Access Compliance Report

Public Rights-of-Way

(Curb Ramps)

Intersection ID: 54365	Main Street: COLLINS_FORD_RD	Cross Street: GANNON_DR	Location: SW
ADA ID: EE460E8A6AD1	Ramp Type: BlendTrans1	Initial Pass/Fail: Fail	Overall Compliance: No
Severity Score: 1.25			
Codes/Mitigation Info/Possible Solution		Field Measurements/Component Compliance

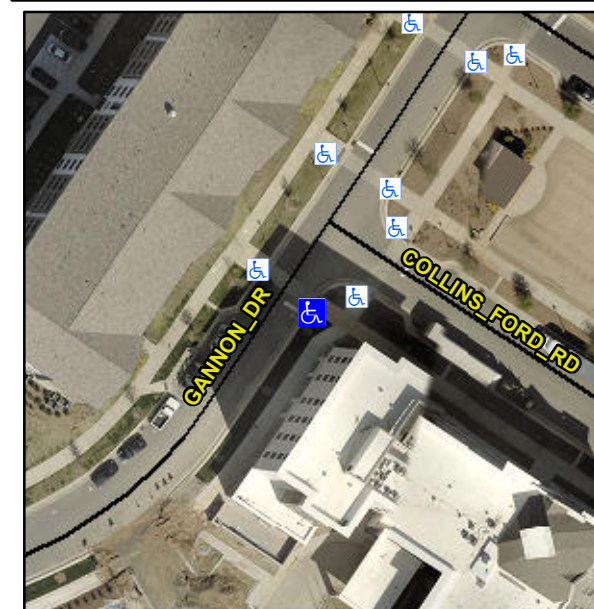
XWALK PAVERS

Not Found, R304.5.3

Compliance	Description	Data	Compliance	Description	Data
N/A	Ramp Length (in)	181.0	Yes	BlendTrans Slope (%)	2.4
Yes	Ramp Width (in)	93.5	No	BlendTrans XSlope (%)	2.2
N/A	Flare Type LT	N/A	N/A	Flare Type RT	N/A
N/A	Flare Slope LT (%)	N/A	N/A	Flare Slope RT (%)	N/A
N/A	Flare Traversable LT?	N/A	N/A	Flare Traversable RT?	N/A
N/A	Landing Length (in)	N/A	N/A	DWS Provided?	N/A
N/A	Landing Width (in)	N/A	N/A	DWS Contrast?	N/A
N/A	Landing Slope (%)	N/A	N/A	DWS Length (in)	N/A
N/A	Landing X Slope (%)	N/A	N/A	DWS Full Width?	N/A
N/A	Landing Curb? (Y/N)	N/A	N/A	DWS Offset (in)	N/A
N/A	Shared Landing?	N/A			
N/A	Gutter Ponding?	N/A	N/A	Gutter Slope (%)	N/A
N/A	Gutter Lip Ht (in)	N/A	N/A	Gutter X Slope (%)	N/A
N/A	Painted X Walk1?	Yes	N/A	Painted X Walk2?	N/A
	X Walk 1 Direction	To NW		X Walk 2 Direction	N/A
	X Walk 1 Width (in)	97.5		X Walk 2 Width (in)	N/A
	X Walk 1 Slope (%)	3.1		X Walk 2 Slope (%)	N/A
	X Walk 1 X Slope (%)	1.4		X Walk 2 X Slope (%)	N/A

N/A	Ramp inside XWalk1?	Yes	N/A	Ramp inside XWalk2?	N/A
	Road Slope (%)	1.4		Clear Space?	N/A
	Road X Slope (%)	3.1	N/A	Clear Space to XWalk (in)	N/A
N/A	Any Obstructions?	N/A	N/A	Storm Grate/Utility Hazard?	N/A
	Obstruction Type			Storm Grate/Utility Type	
		N/A			N/A
		Yes		Surface Condition? (G/P)	Good
		No		Curb Slope (%)	9.7

Remove & Replace Curb Ramp With Two New Directional Ramps or Equivalent.
